### +TREE COMMISSION TREE REMOVAL REPORT CITY of KEY WEST

PROPERTY: 1671 Dunlap Dr

APPLICATION NUMBER: TP2025-0003

REQUEST: Property owner is seeking conceptual landscape plan approval with removal of (3) Royal Poincianas, (5) Jamaican Dogwoods, (1) Strangler Fig, (3) Buttonwoods, (3) Gumbo Limbos, (4) Coconut Palms, and (2) Washingtonian Palms.

L-2

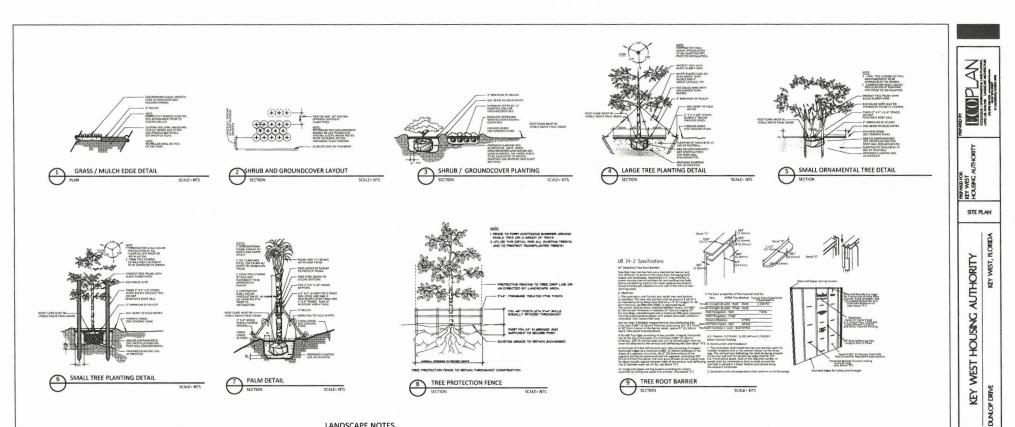
Final Landscape Plan Review:

- The tree removal permit for the landscape plan and the tree removal permit T2024-0333 for (3) buttonwoods would require the planting of 288.4 caliper inches and (6) Native palms 4ft OH minimum. The plans dated 4/28/25 and reviewed on 4/29/25 exceed those required replacements in the landscape plan. See the table above

- 3. City Code Sec 108-412 requires that proposed vegetation in landscaping be a minimum of 70% native vegetation. The proposed plan incorporates 100% of native species, which will result in the property consisting of 99% of native vegetation. City Code Sec 108-481 states that if palms are used, they shall constitute no more than 25% of the total tree requirement. The proposed palms total to 13% of the proposed plantings; and 13% of the total vegetation.

- 4. All invasive, exotic vegetation shall be removed (Brazilian Pepper, Seaside Mahoe, Lead Tree, Australian Pines)
- 5. The landscaping will be appropriate and aesthetically attractive for this development.

- A. Removal of (15) regulated/ protected dicots and 6 regulated/protected palms
- B. Final Landscape Plan with the proposed replacement of 549.9 caliper inches (based on associated ratios for certain species) and 19 approved palms (based on associated ratios for heights)
  - a. This is with the condition that Planning Board approves the plan as well
